Product Change Notification (PCN)

PCN Number:	PCN_IndSD_20270105
Affected Series:	WE-SD
Affected Part Number:	see table "PART NUMBER, REVISION & DATASHEET"
PCN Date:	2026-10-05 (YYYY-MM-DD)
Effective Date:	2027-01-05 (YYYY-MM-DD)

744710205	**Before change**	**After change**
Packaging Drawing Bag / Tray:		
Packaging Drawing Inner Carton:		
Packaging Drawing Outer Carton:

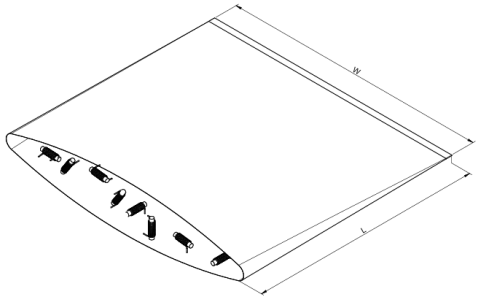
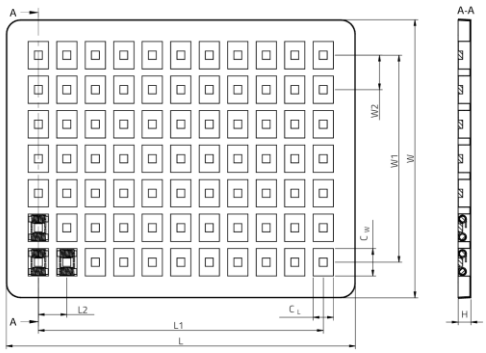
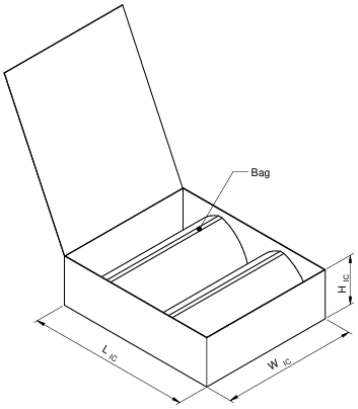
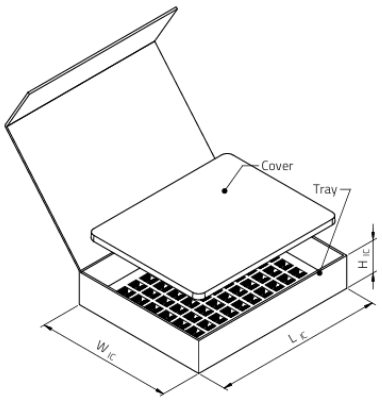
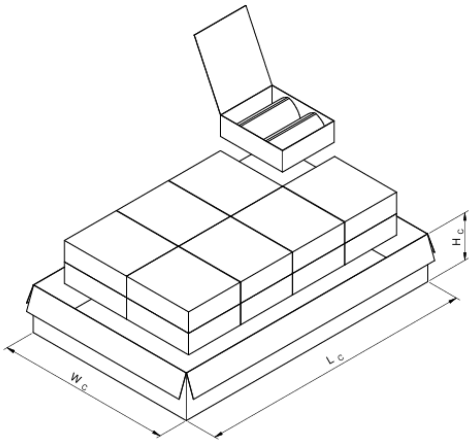
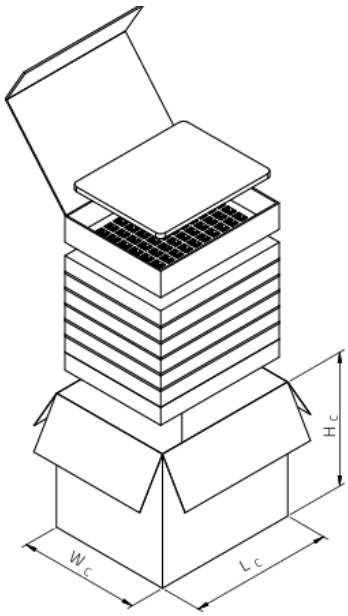
Due to packaging optimizations, Würth Elektronik eiSos will change the packaging of the WE-SD 744710205 from bulk to tray.
There will be no change in fit, form, function, quality or reliability of the product.
The new revision of the affected part numbers will be sent out after the previous revision is out of stock (according to FIFO - first-in, first-out).
The preliminary datasheets of the affected part numbers which are available in the online catalogue will be available on the website after the PCN date. Link to the website: WE-SD

Packaging Specifications Bag / Tray:	Length L: Width W: Quantity: Material:	255.0 mm 240.0 mm 100 pcs. PE	Length L: Length L1: Length L2: Width W: Width W1: Width W2: Height H: Cavity Length C_L: Cavity Width C_W: Quantity: Material:	245.0 mm 200.0 mm 20.0 mm 195.0 mm 145.2 mm 24,2 mm 8.5 mm 14.2 mm 19.2 mm 154 pcs. PET
Packaging Specifications Inner Carton:	Length L_{IC}: Width W_{IC}: Height H_{IC}: Number of bags: Quantity: Material:	150.0 mm 125.0 mm 45.0 mm 2 pcs. 200 pcs. Paper	Length L_{IC}: Width W_{IC}: Height H_{IC}: Number of trays: Quantity: Material:	260.0 mm 210.0 mm 217. mm 21 pcs. 3234 pcs Paper
Packaging Specifications Outer Carton:	Length L_C: Width W_C: Height H_C: Number of inner cartons: Quantity: Material:	584.0 mm 370.0 mm 100.0 mm 16 pcs. 3200 pcs. Paper	Length L_C: Width W_C: Height H_C: Number of inner cartons: Quantity: Material::	275.0 mm 232.0 mm 255.0 mm 1 pcs. 3234 pcs. Paper

744710603	**Before change**	**After change**
Correction Coil Width:

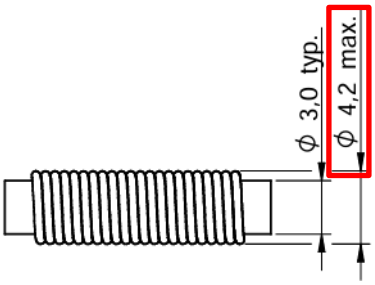
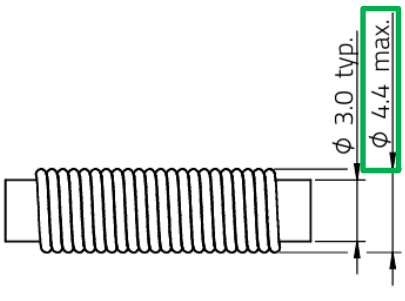
As a datasheet information correction, Würth Elektronik eiSos will correct the coil width in the drawing of the WE-SD 744710603 from 4,2 mm (max.) to 4,4 mm (max.).
This is a datasheet correction only. There will be no change in fit, form, function, quality or reliability of the product.
